Service Bulletin

CBR1000 #11
December 2024

SAFETY RECALL

2008-2016 CBR1000RR/RA Fuel Pump Inspection / Replacement

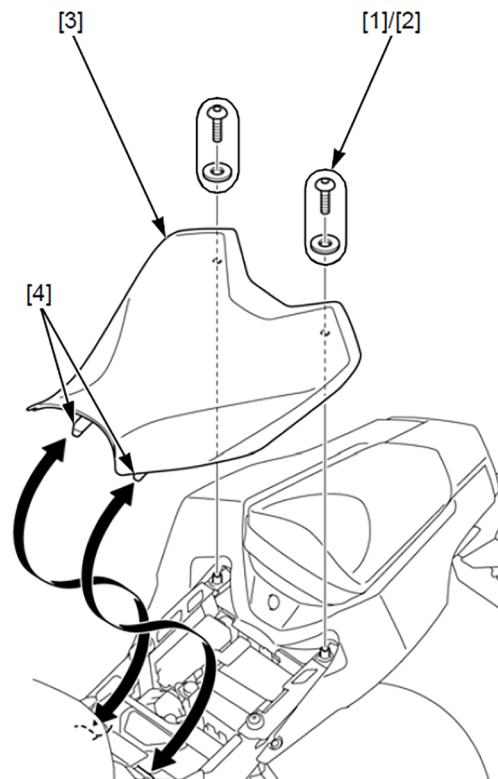
The fuel pump number must be inspected to determine if the fuel pump lot number is in the range to be replaced.

Inspect the identification label [1] affixed to the top of the fuel pump.

1. Check the part number of the pump.

For pumps with the last three digits of the part number **are not 013**, the pump **does not** need to be replaced and no repair is required. Proceed to filing an “Inspection Only” warranty claim.

For pumps with the last three digits of the part number **are 013**, proceed to step 2 to check the LOT number.

2. Check the LOT number located in the bottom right-hand corner of the label. If the LOT number shows a production date that is between July 28, 2017 and June 9, 2020, the fuel pump must be replaced following the FUEL PUMP REPLACEMENT procedure on [page 6](#).

Replace the fuel pump if the LOT number is between 07U28 and 06D09 (July 28, 2017 and June 9, 2020).

FUEL PUMP REPLACEMENT

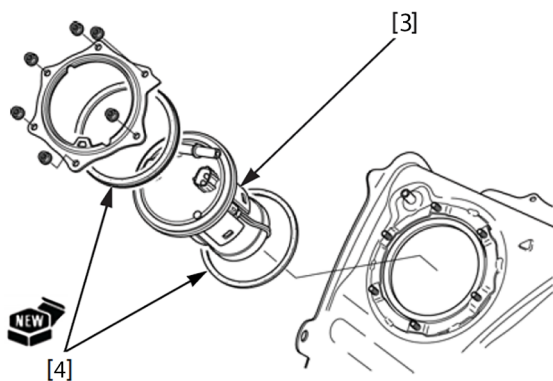
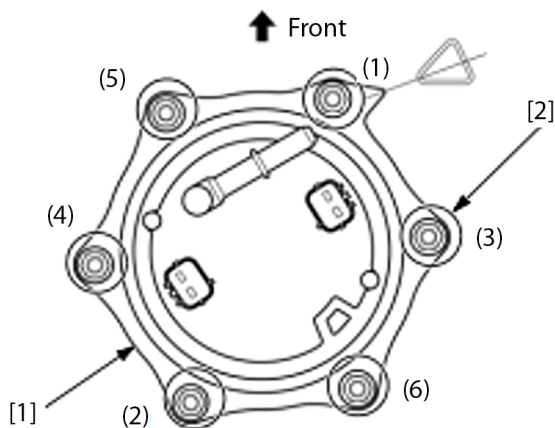
1. Remove the fuel pump unit mounting nuts [1] and setting plate [2].

2. Remove the fuel pump unit [1] and packings [2].

Installation is the reverse order of removal.

- Place new packings [4] onto the fuel pump unit [3].
- Install the new fuel pump unit to the fuel tank.
- Be careful not to damage the pump wire.
- Install the setting plate [2] and tighten the fuel pump mounting nuts [1] to the specified torque in the specified sequence as shown.

12 N·m (1.2 kg-m, 106 in·lb)
